# UNITED STATES PATENT AND TRADEMARK OFFICE

APPLICATION NO.	FILING DATE	FIRST NAMED INVENTOR	ATTORNEY DOCKET NO.	CONFIRMATION NO.
10/550,271	09/23/2005	Hiroyasu Yumura	017700-0177	1269

<b>Office Action Summary</b>	<b>Application No.</b> 10/550,271	<b>Applicant(s)</b> YUMURA ET AL.	
	<b>Examiner</b> Sheldon S. Soon	<b>Art Unit</b> 2841

## **DETAILED ACTION**

Figures 4 and 5  
taken from Snowden

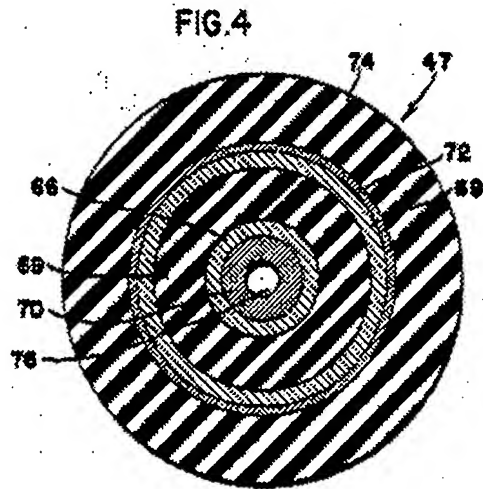
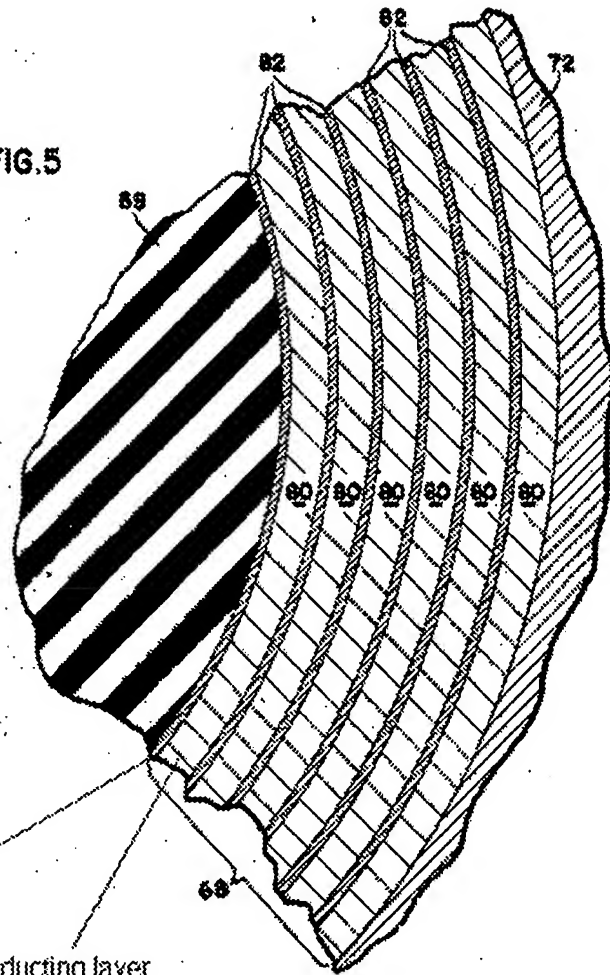
Regarding claim 1 – Snowden discloses all the elements of the instant invention including: a former made of a normal-conducting metal (item 70, column 5 line 71); a first superconducting layer (item 66, column 4 lines 58-59) formed around the outer circumference of said former and in electrical communication with the former (figure 4 shows them to be in direct contact with no intermediate layer); an electric insulating layer (item 69, column 4 line 1) formed around the outer circumference of said first superconducting layer; a second superconducting layer (item 80, column 4 lines 68-69) formed around the

outer circumference of said electric insulating layer; and  
a normal-conducting metal layer (item 82, column 4 lines 64-66) formed between said electric insulating layer and said second superconducting layer;  
wherein said first and second superconducting layers are in a state cooled by a refrigerant (as disclosed in column 4 line 56).

Regarding claim 4 - Snowden in view of Perez discloses all the elements of claim 3 and further discloses: a wire insulating layer (item 74 in figure 4 of Snowden, column 4 lines 44-45) around the wires' outer circumferences.

Upon closer examination of the prior art of Snowden, the superconducting layer shown as item 68 is further disclosed as several thinner layers of which the inner most layer is

disclosed as a normal conductor with the next outer layer being a superconductor.

Such structure completely anticipates the applicant's invention thereby rendering the previous 35 U.S.C. 103 rejection moot.

Figure 1 taken from Perez

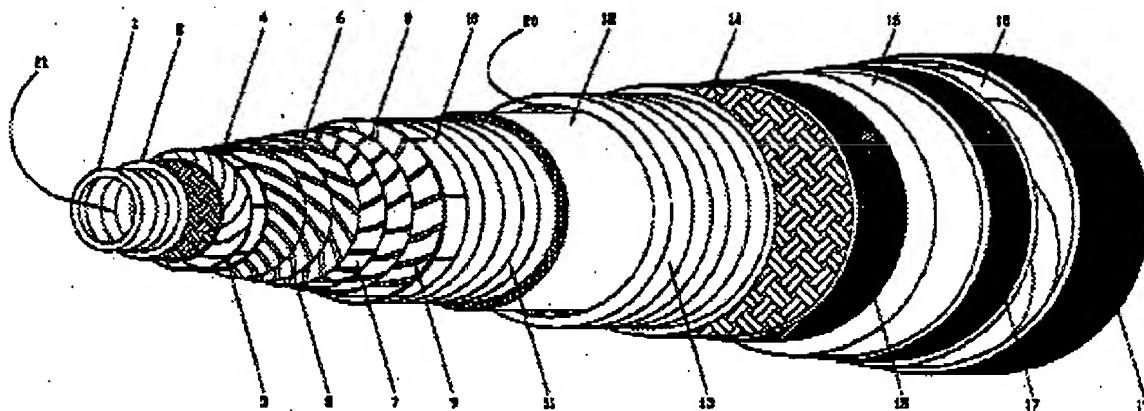
Regarding claim 3 - Snowden discloses all the elements of claim 1 but fails to disclose: the normal-conducting metal layer is formed by winding round wires with a round cross section or tape-shaped wires formed from a normal-conducting metal. Perez teaches

the use of a layer of wrapped copper tape (item 3 in figure 1). It would have been obvious to someone of ordinary skill in the art at the time of the invention to use the wrapped conducting tape method of Perez in the cable of Snowden since it was known to be an economical method in lieu of other methods (i.e. sputtering, vapor deposition, electroplating, ect.).
